# Lauprete Residence

Conservation Commission Presentation  
FEBRUARY 23, 2021

# SHIFTING THE POOL TOWARD ROAD: DOESN'T WORK SPATIALLY

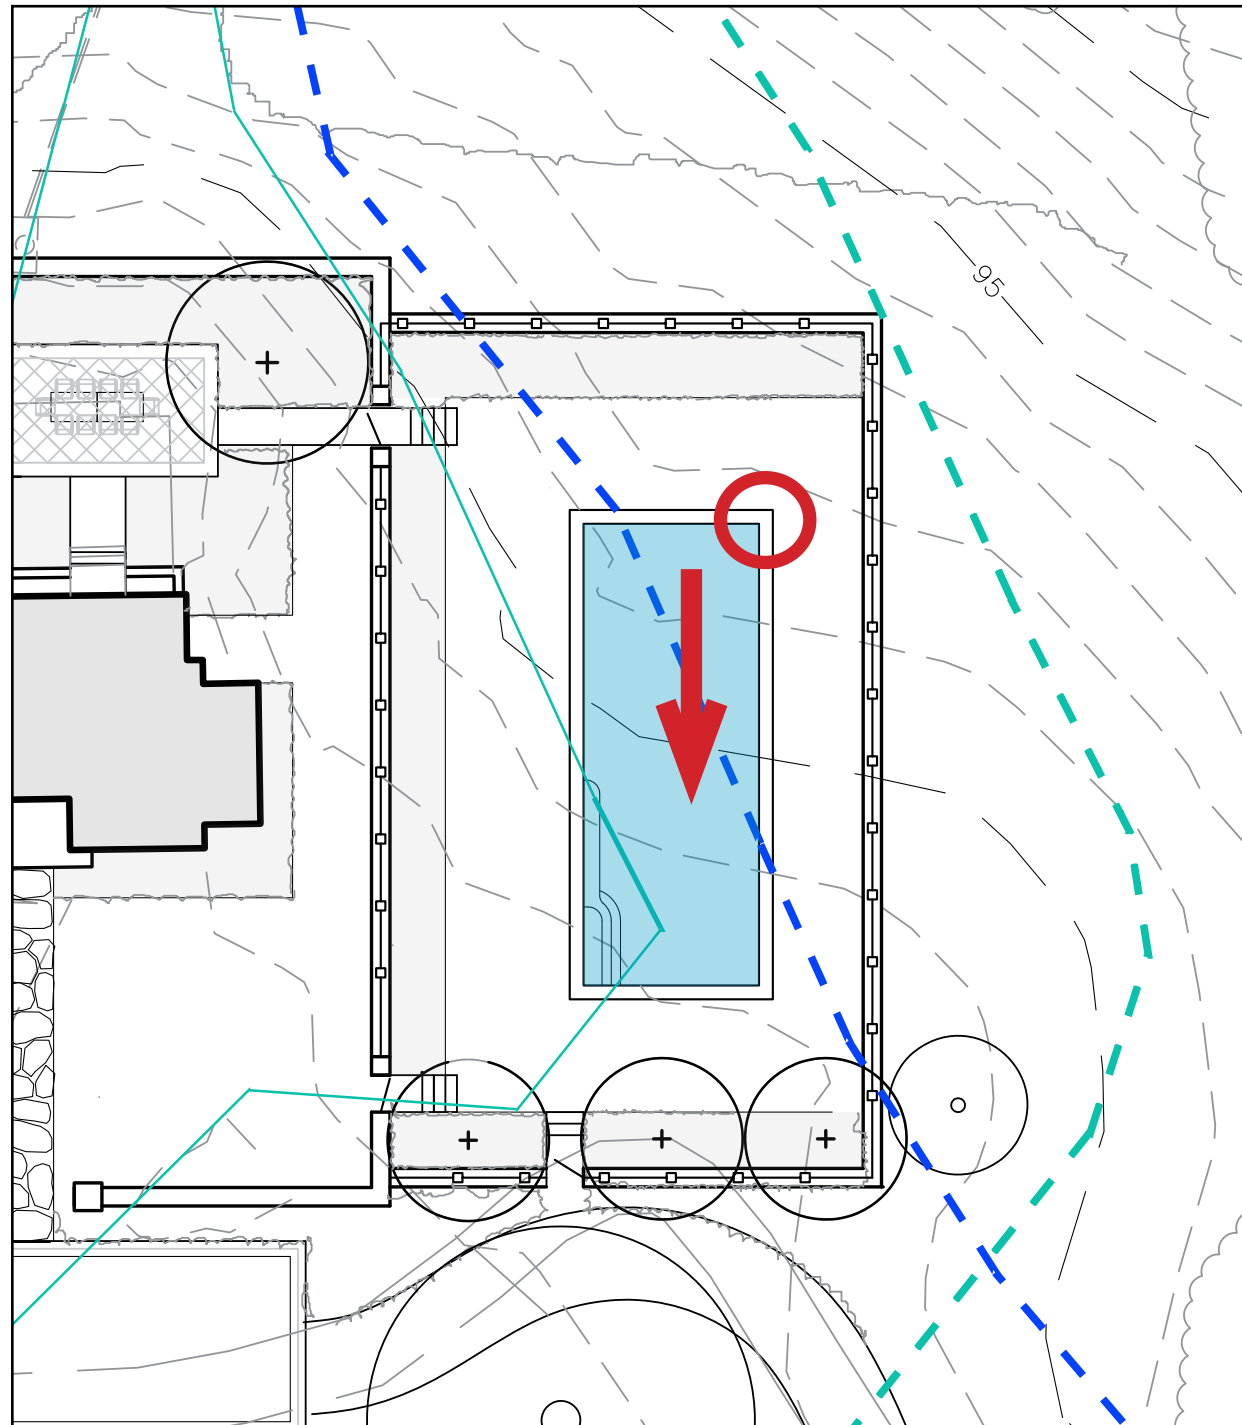
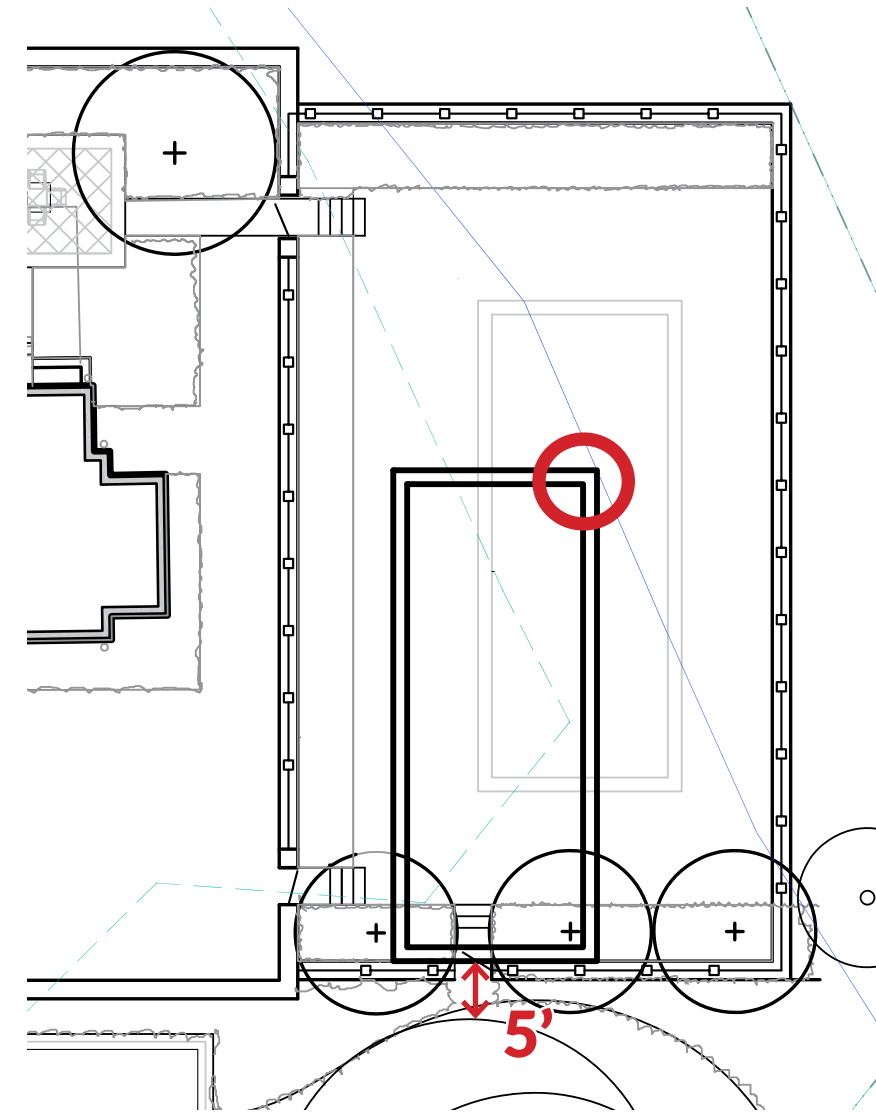
SHIFTING POOL TOWARDS THE ROAD UNTIL IT CLEARS THE 100' RFA

- EDGE OF POOL BECOMES POOL ENCLOSURE FENCE
- ONLY 5' BETWEEN EDGE OF ROAD TO EDGE OF POOL/ WALL (WIDTH OF A MINI COOPER)
- CIRCULATION NO LONGER FUNCTIONS OR MAKES SENSE
- RETAINING WALL AND TURF AREA AROUND POOL WOULD STILL ENCROACH OVER 100' RFA
